11-08 LATEST REVISION DATE <i>Thomas E. McQuinn</i> APPROVED BY BRIDGE ENGINEER		
	STANDARD DESIGN - 40' ROADWAY, 3 SPAN BRIDGES CONTINUOUS CONCRETE SLAB BRIDGES NOVEMBER, 2006	
	SUPERSTRUCTURE DETAILS 100'-0 BRIDGE	J40-08-06

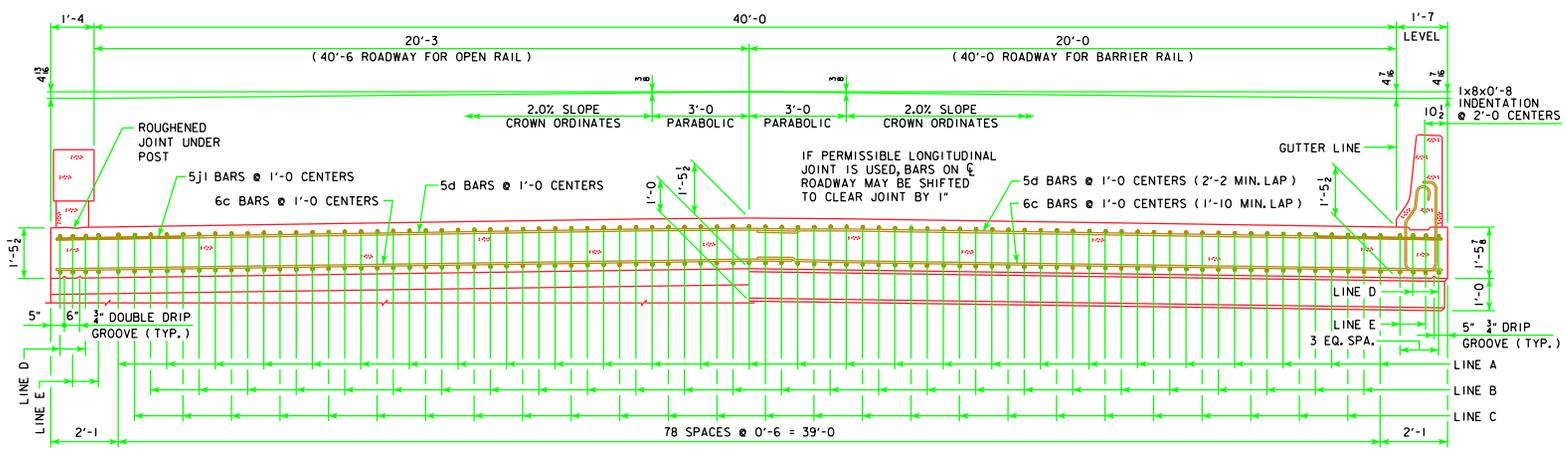
REVISED 11-08 - CHANGED DISTANCE OF END OF REBAR TO $\bar{\bar{C}}$ OF ABUTMENT BEARING FROM 1'-4 TO 3 INCHES. REMOVED PERMISSIBLE LONGITUDINAL CONSTRUCTION JOINT.
